# Technical Document LA19032

Application under the *Agricultural Operation Practices Act* for a confined feeding operation, manure collection area, and/or manure storage facility(ies)

<b>NRCB USE ONLY</b>	Application number	Legal land description
<input checked="" type="checkbox"/> Approval <input type="checkbox"/> Registration <input type="checkbox"/> Authorization <input type="checkbox"/> Amendment	<u>LA19032</u>	<u>NE 7-7-20 W4M</u>

**Re: Geotechnical Review and Evaluation  
Proposed Feedlot Pens & Catchbasin  
NE-07-007-20-W4M, near Raymond, Alberta**

**A CROSS SECTION**  
 A4 1/16" = 1'-0"

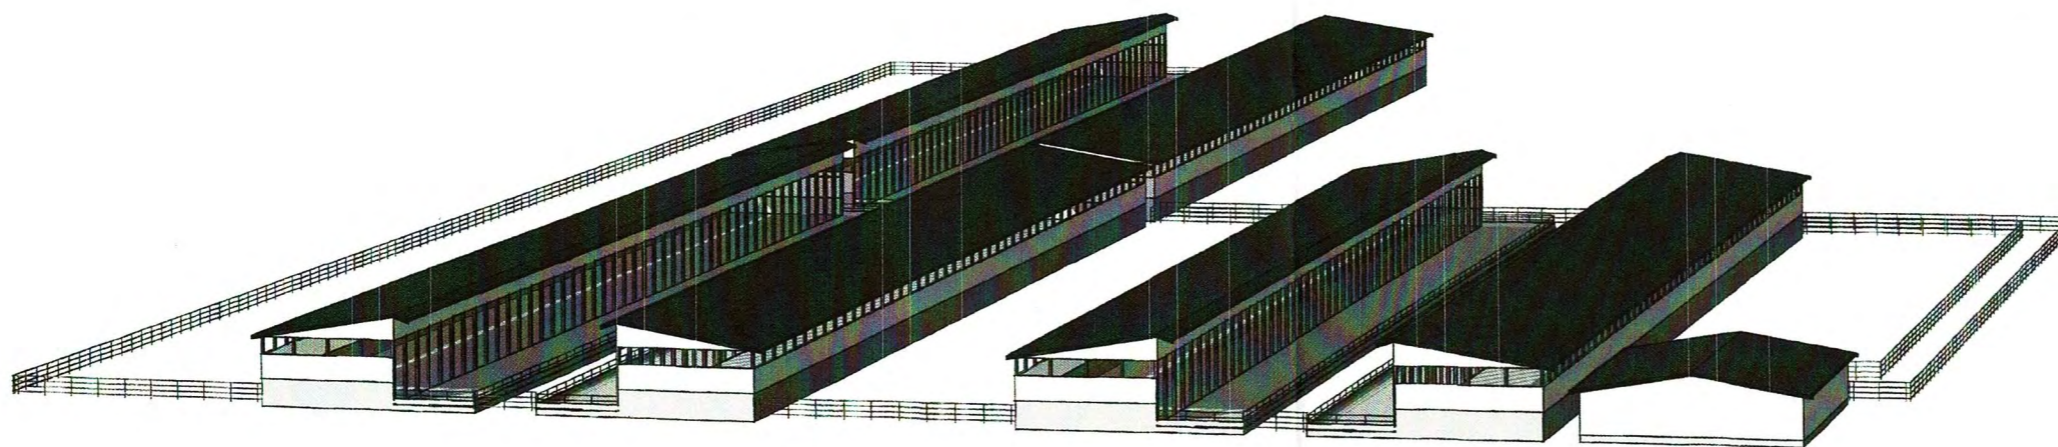
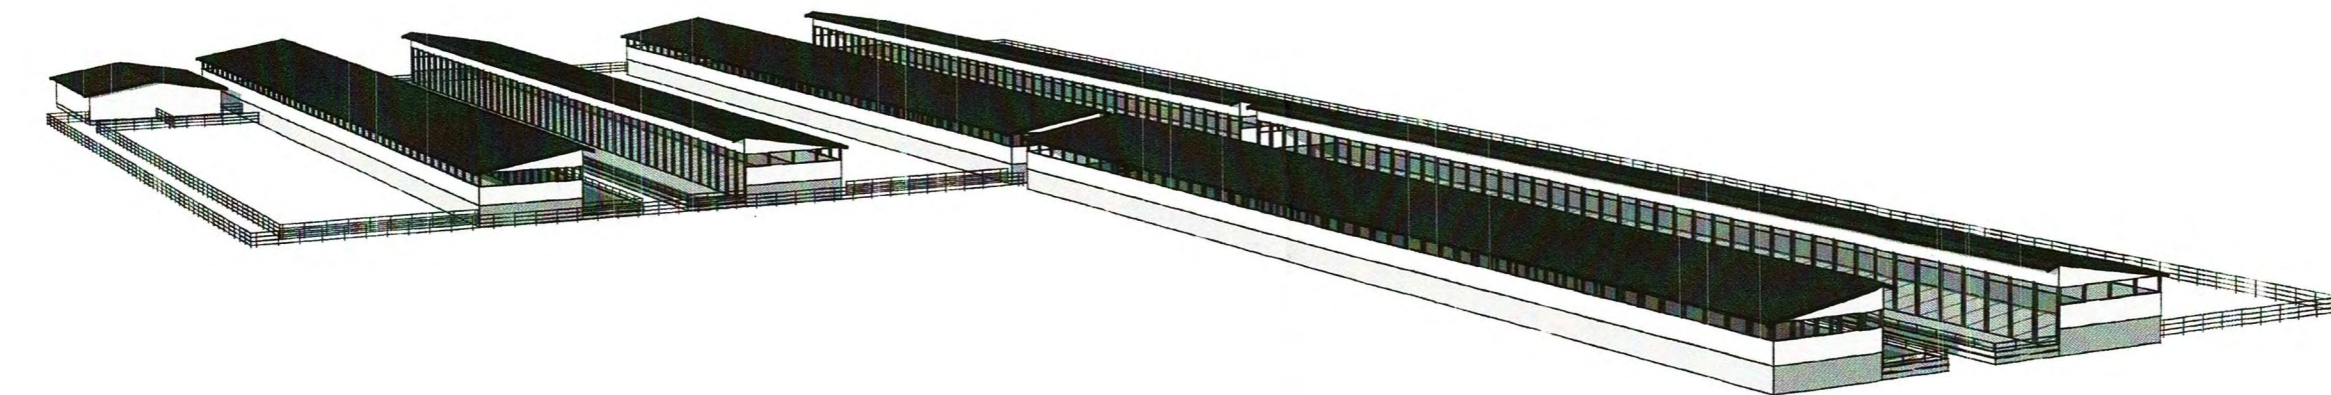
Proposed facilities	Dimensions (m) (length, width, and depth)
6 corrals/shelters <span style="border: 1px solid red; padding: 2px;">Pens #1- #6 (19.5 m x 137.2 m dimensions of each)</span>	64' x 450'
1 processing barn/office	60' x 80'
1 commodity shed	40' x 80'
<span style="border: 1px solid red; padding: 2px;">Catch basin</span>	<span style="border: 1px solid red; padding: 2px;">75 m x 35 m x 4.5 m</span>

# Catch Basin Dimension Calculator

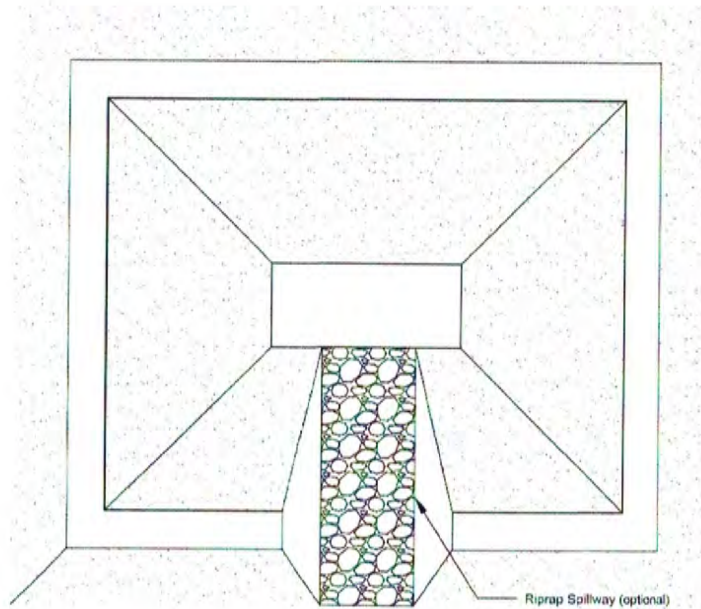
AO note: potential contributing area (including non manure storage areas) is approx 350 m x 175 m (see next page)

Catch basin calculator. Total volume @ freeboard level: 4992 m<sup>3</sup> Runoff capacity requirements met:  YES  NO

The catch basin dimensions meet the design requirements in AOPA
